**CITY OF FRANKLIN****REPORT TO THE PLAN COMMISSION****Meeting of November 21, 2019****Special Use and Site Plan Amendment**

Project Name:	The Learning Experience Special Use and Site Plan Amendment
Project Address:	7760 Lovers Lane Road
Applicant:	Gary Wendt, Bradford Franklin LLC
Property Owner:	Franklin-Wyndham, LLC
Current Zoning:	CC City Civic Center District
2025 Comprehensive Plan	Mixed Use
Use of Surrounding Properties:	Single-family residential to the north, stormwater detention pond to the south, Risen Savior Lutheran Church to the east and Summit Credit Union to the west
Applicant Action Requested:	Recommendation of approval for the proposed Special Use and associated Site Plan for the development of The Learning Center daycare facility.

Designed By
SAH
Drawn By
SAH
Checked By
MJC
Date
3/18/2019
Job Number
CE180034
Sheet Number
SITE

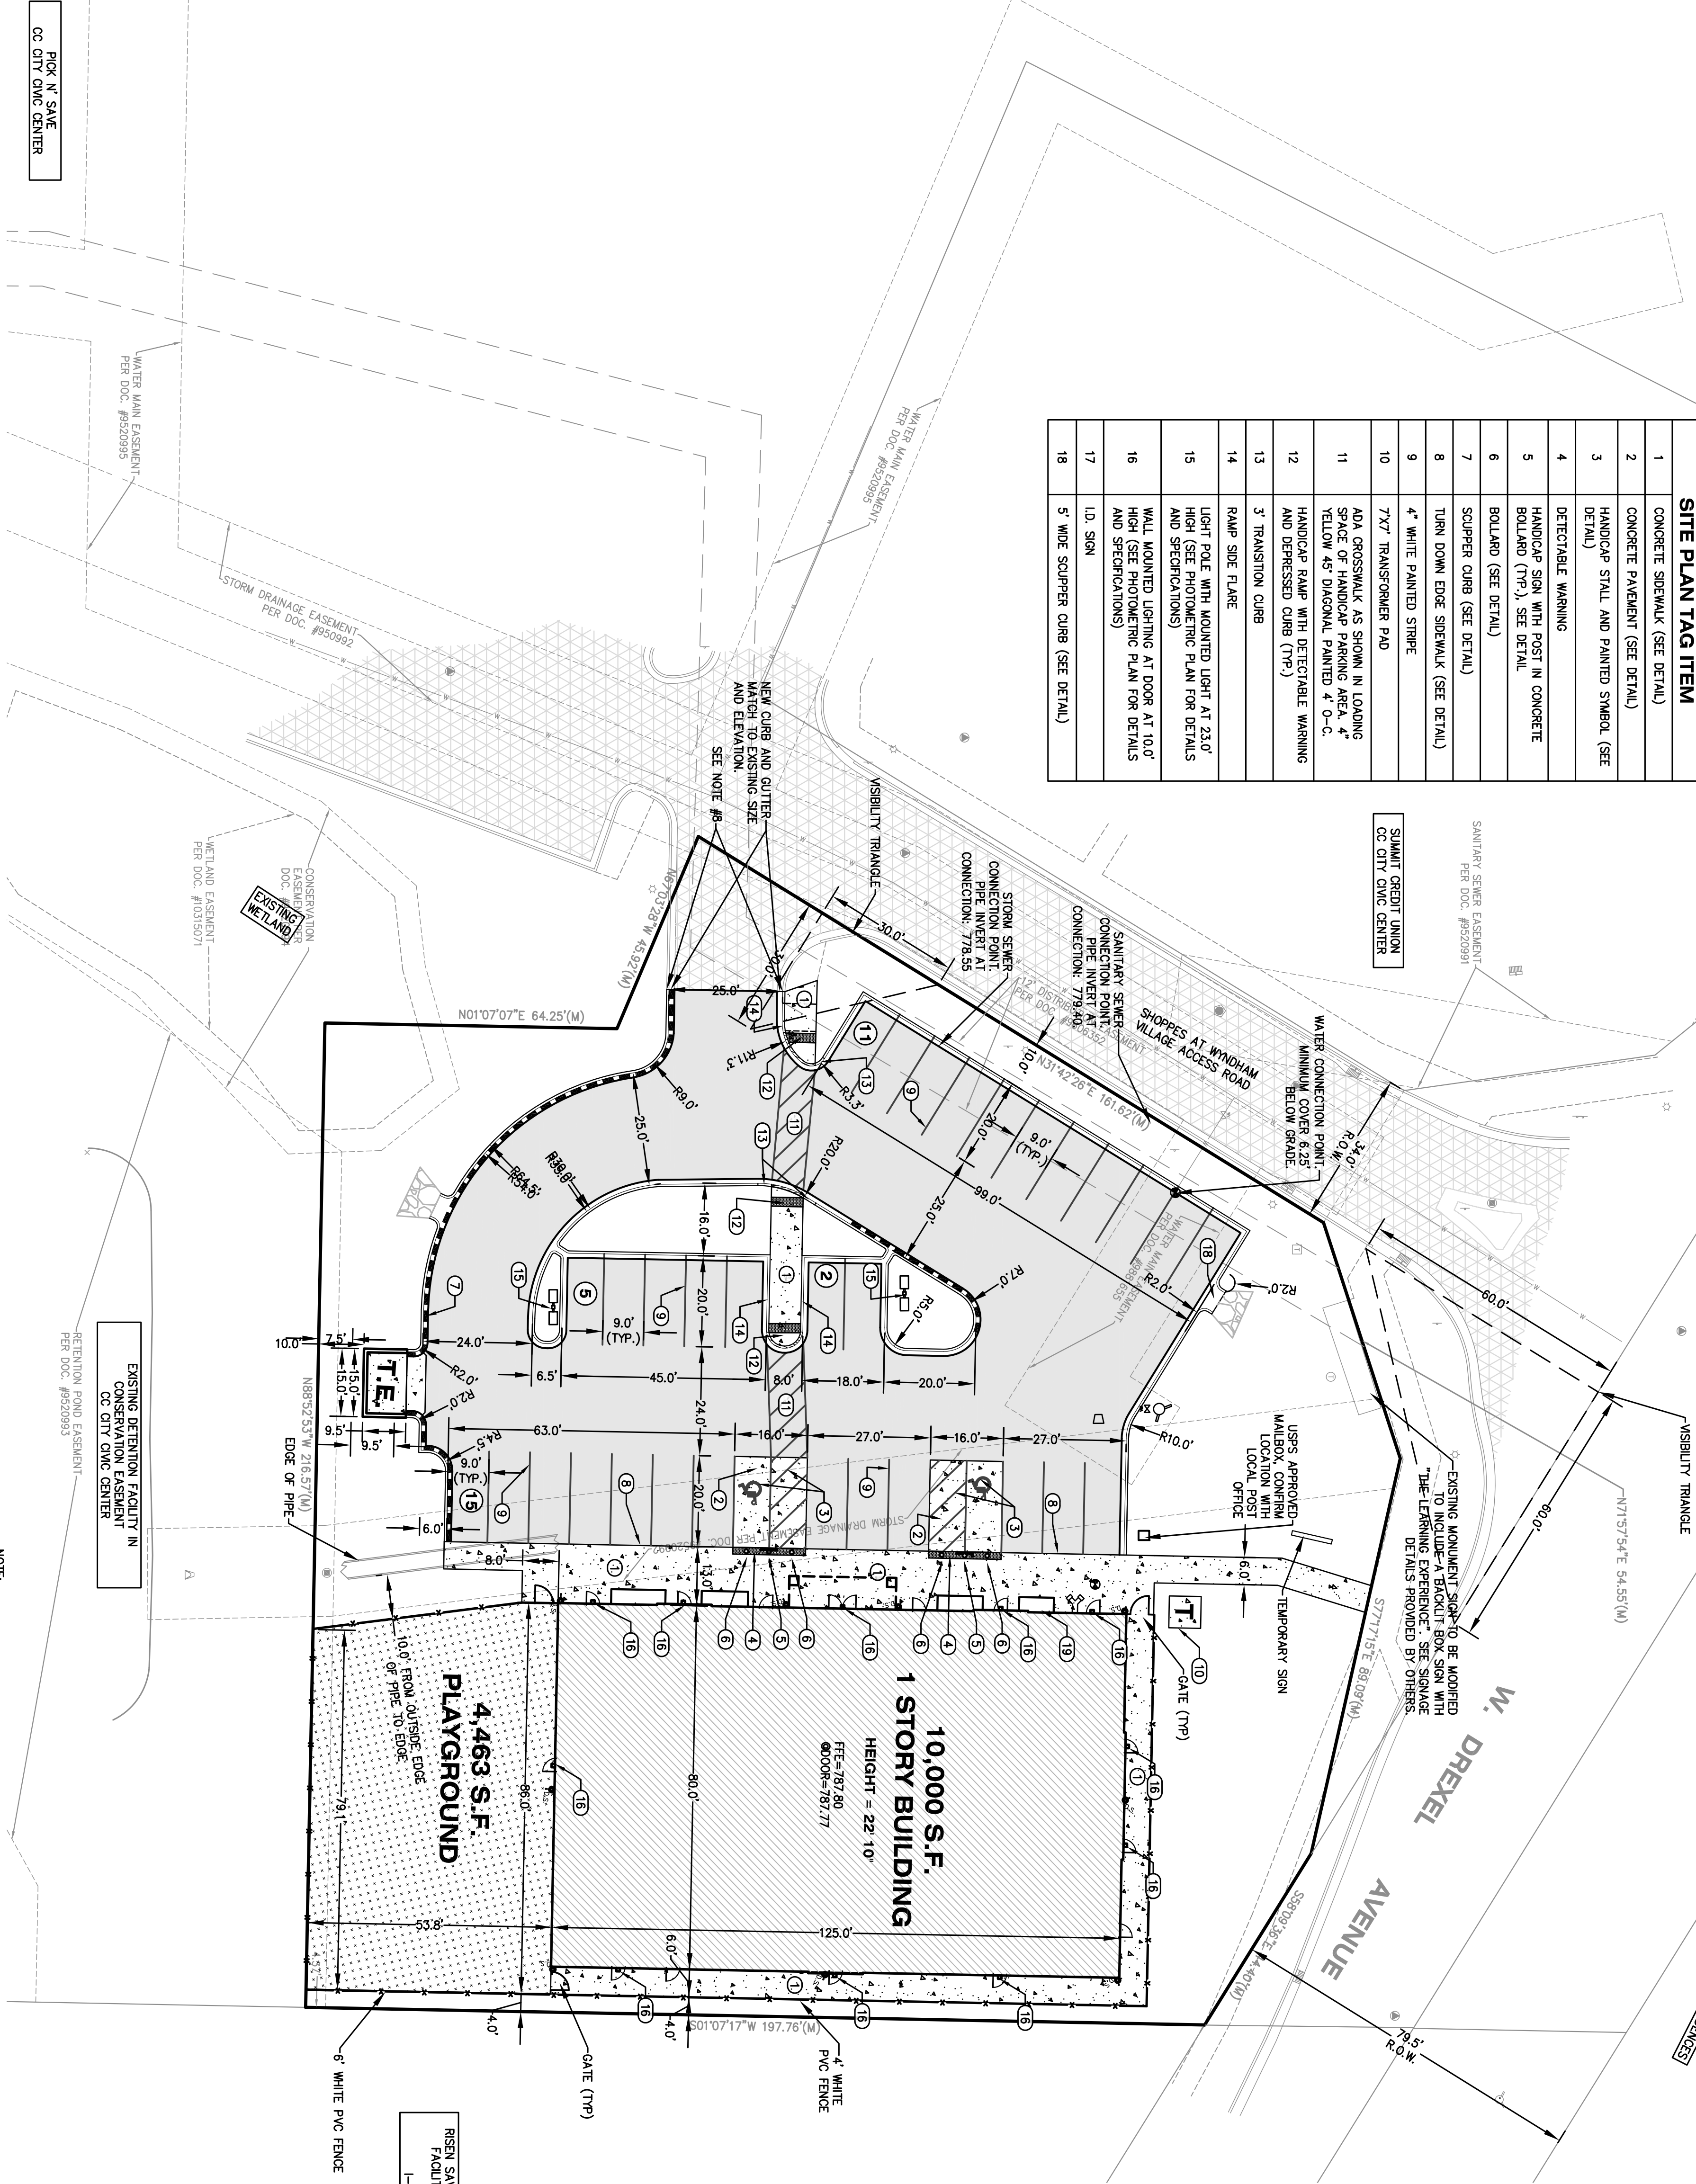
- f. Illustrate and label the vision triangle on the Site Plan (see below).

Comment 5: Staff recommends that a cross-access easement be provided and illustrated on the Site Plan to allow access to the church property to the east. The CC District requires cross-access between parcels. Staff recommends that the cross-access driveway or drive lane be paved at the time of development of The Learning Experience facility.

Comment 6: In the Plan Commission submittal, please request Plan Commission approval to have driveway wider than 24 feet at the street right-of-way line and 30 feet at the roadway, per § 15-5.0207B.

Comment 8: Please provide parking lot island dimensions to verify they meet depth requirements, pursuant to § 15-3.0354C.2.

Response 2f: These areas are shown on the Site Plan.

Response 5: Per our discussions the reasonable development of this very difficult lot will not allow both the TLE Project and the cross-access easement. Please also see response to to comment 1 above.

Response 6: Please see note 8 on project site plan. "Per City Planning Staff a width of driveway is requested to match the previously approved driveway.

Response 8: We have added parking lot island dimensions to the plan.

OVERALL LANDSCAPE PLAN

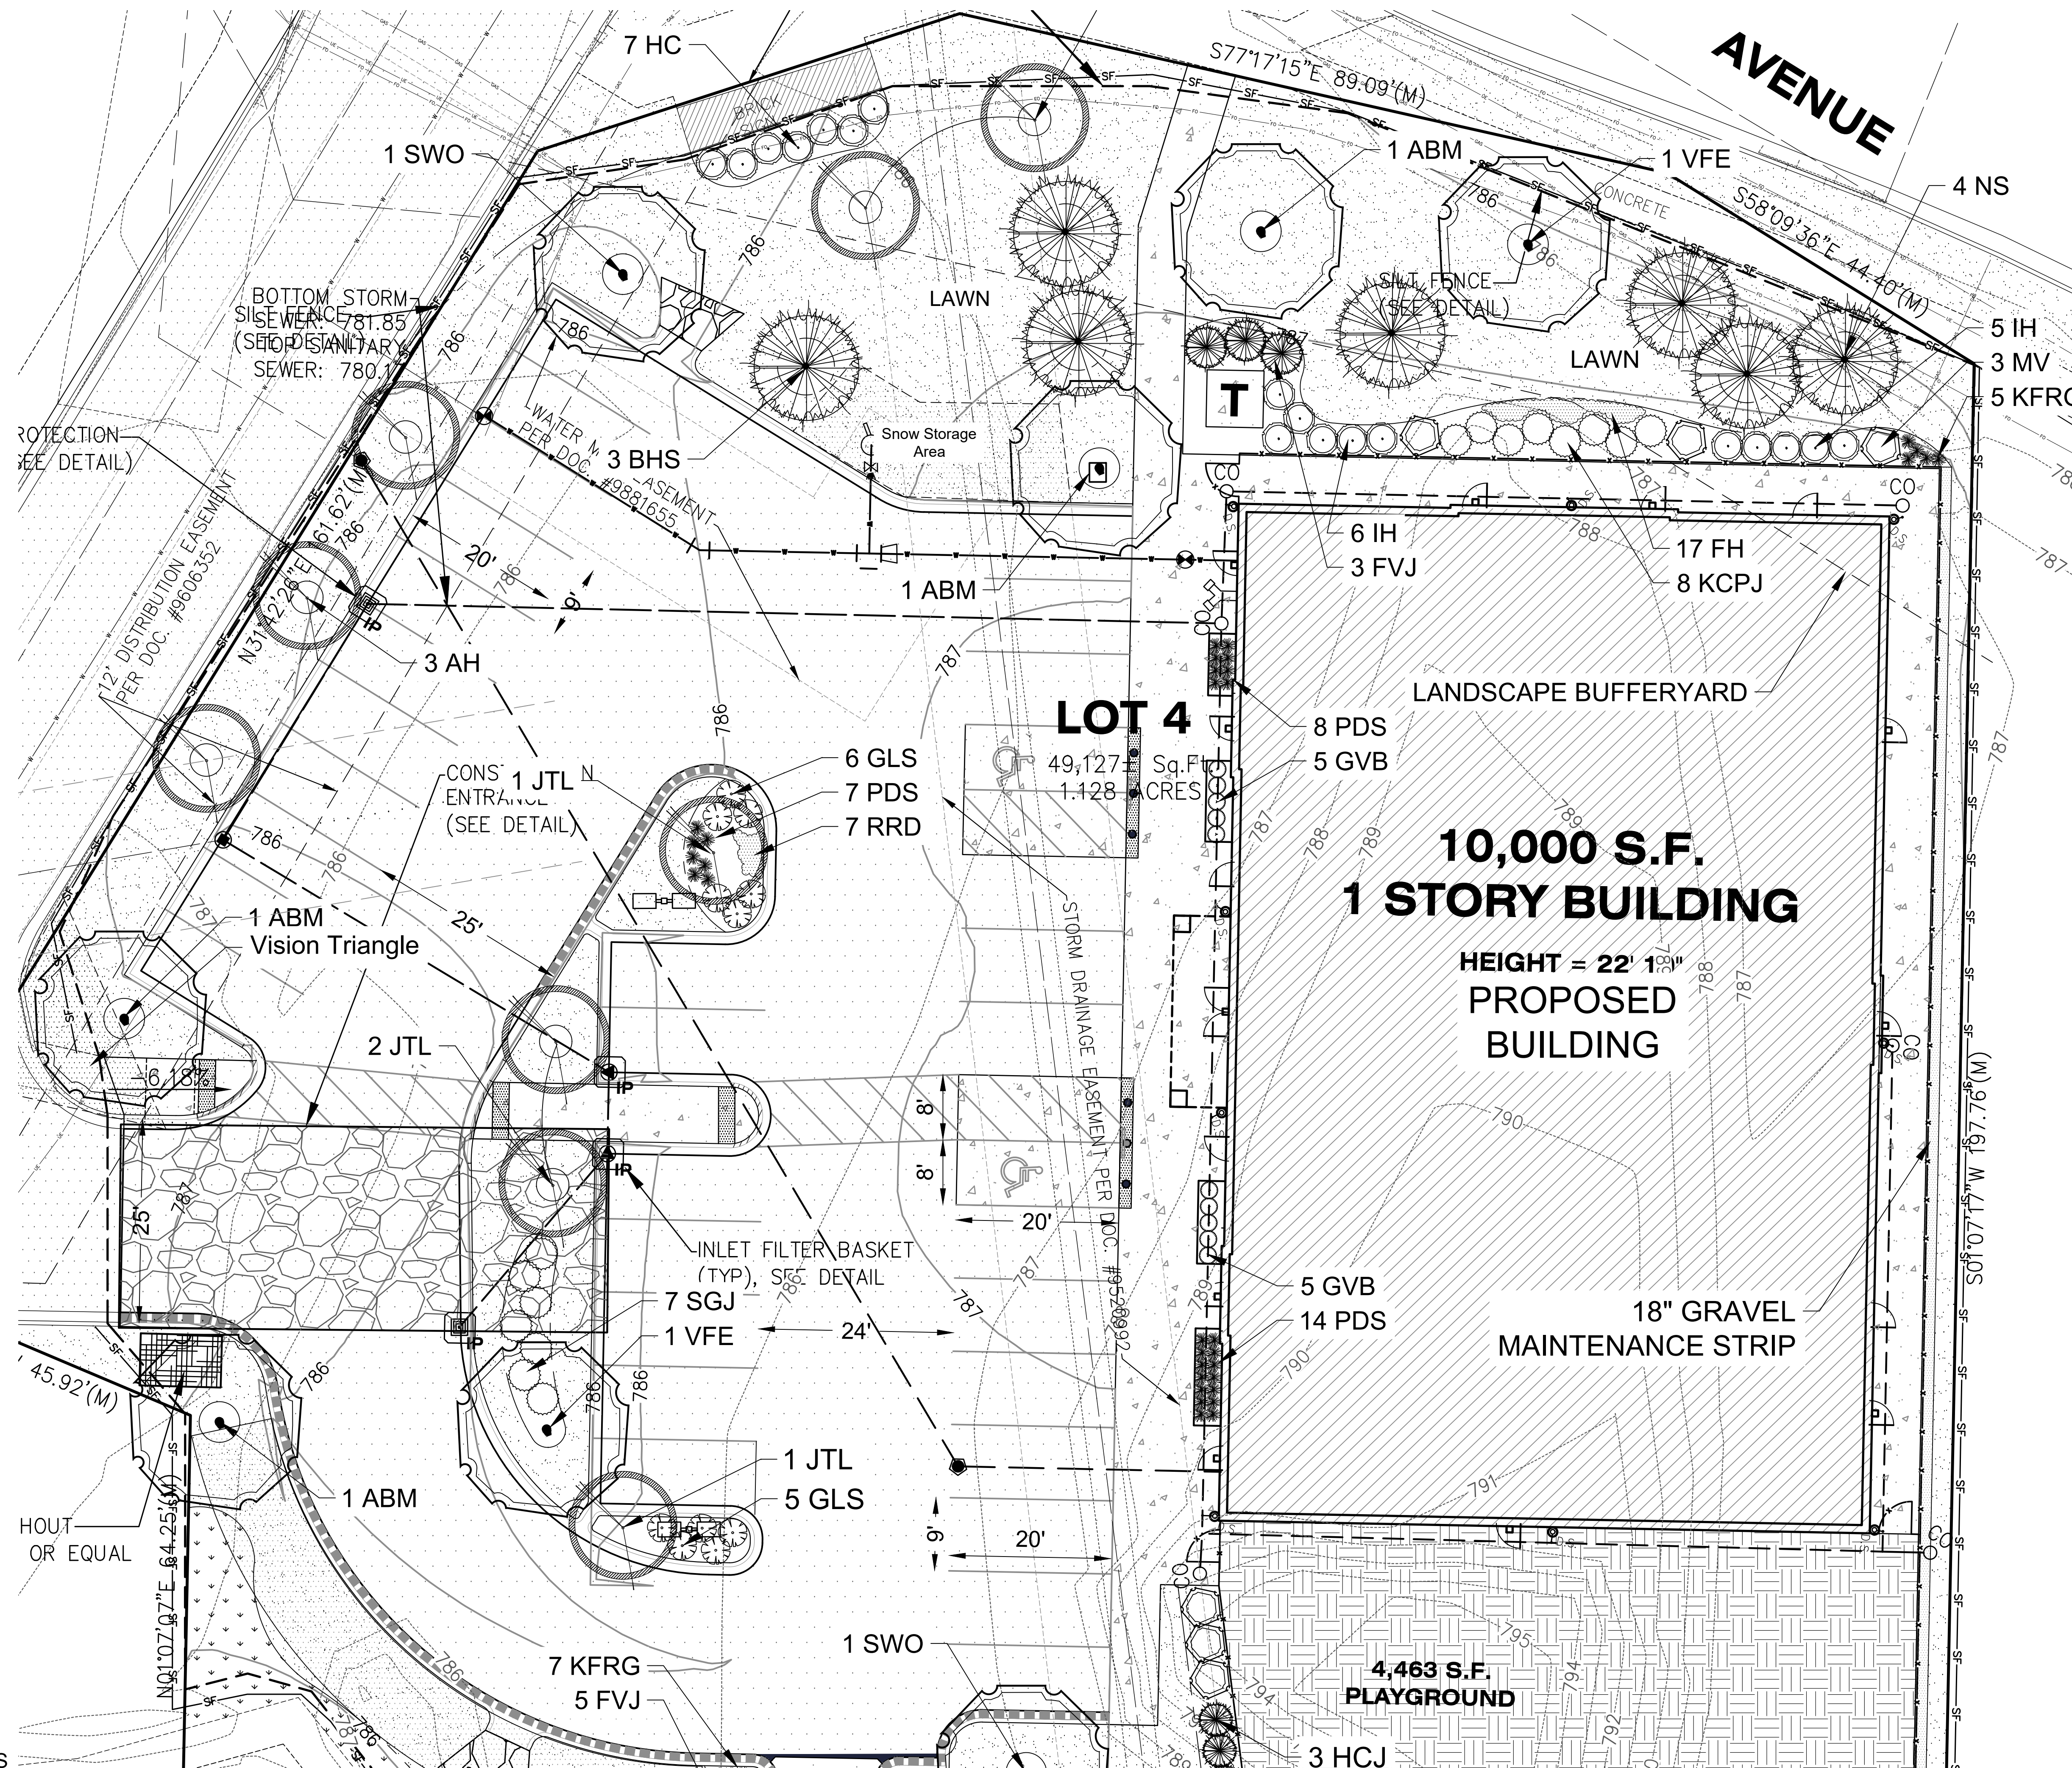
Comment 11: Pursuant to § 15-5.0302..C, a 30 foot bufferyard is required along Drexel Avenue due to the presence of R-3E zoning district across the street to the north. Staff recommends clustering additional plantings along the northern property line. Please add and label bufferyards to the Landscape Plan. Please update the landscaping calculations on the Landscape Plan to reflect the increased requirements for the bufferyards. Note that the initial phase of the Shoppes of Wyndham Village development was not required to have a landscape buffer easement as additional landscaping was planted on the north side of Drexel.

Comment 15: Please illustrate areas for snow storage on the Landscape Plan in compliance with § 15-5.0210 of the Unified Development Ordinance.

Response 11: Bufferyard requirements match Shoppes of Wyndham village

The landscape plan has been updated to reflect plantings along Drexel Avenue to reflect the Development Landscape Master Plan:

Response 15: See Landscape drawings for snow storage areas
